# UNITED STATES PATENT AND TRADEMARK OFFICE

APPLICATION NO.	FILING DATE	FIRST NAMED INVENTOR	ATTORNEY DOCKET NO.	CONFIRMATION NO.
10/524,185	10/11/2005	Kerry D Hinson	60680-2004	2663

<b>Office Action Summary</b>	<b>Application No.</b> 10/524,185	<b>Applicant(s)</b> HINSON ET AL.	
	<b>Examiner</b> Zelalem Eshete	<b>Art Unit</b> 3748

## DETAILED ACTION

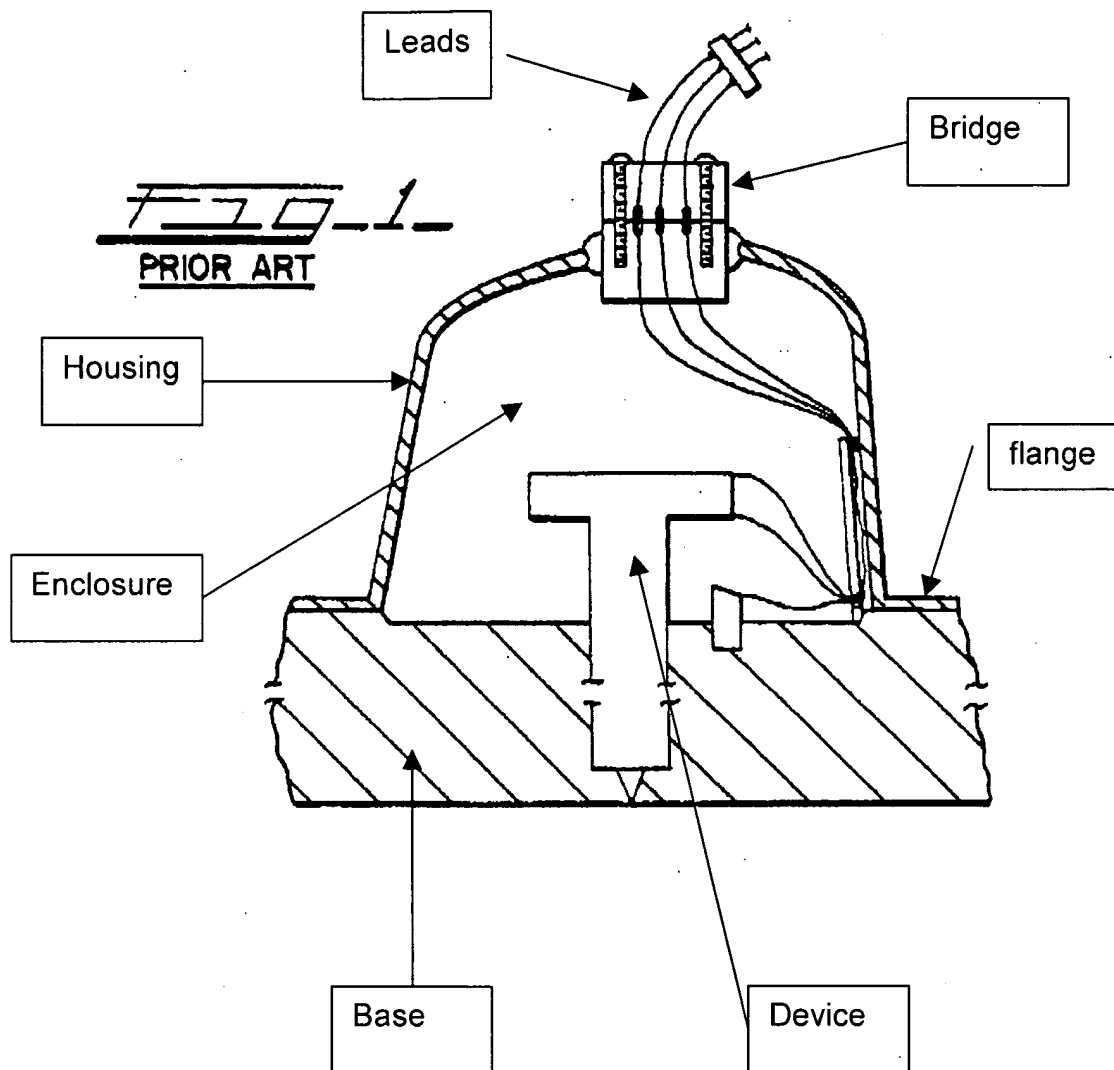
Regarding claims 1,3: Mathew discloses a cover with an electrical bridge comprising a base component; a housing mounted to the base component defining an enclosure therein; at least one electrical connector integrally formed with the housing, the at least one electrical connector including one or more electrical leads integrally formed with the housing that extend through the housing for allowing electrical energy to pass from an electrical source outside the housing to an electrical device within the enclosure, thereby forming an electrical bridge between the electrical source and the electrical device (see labeled figure below).

Regarding claim 7: Mathew as modified above discloses the housing comprises a bottom "pan" flange (see labeled figure above).
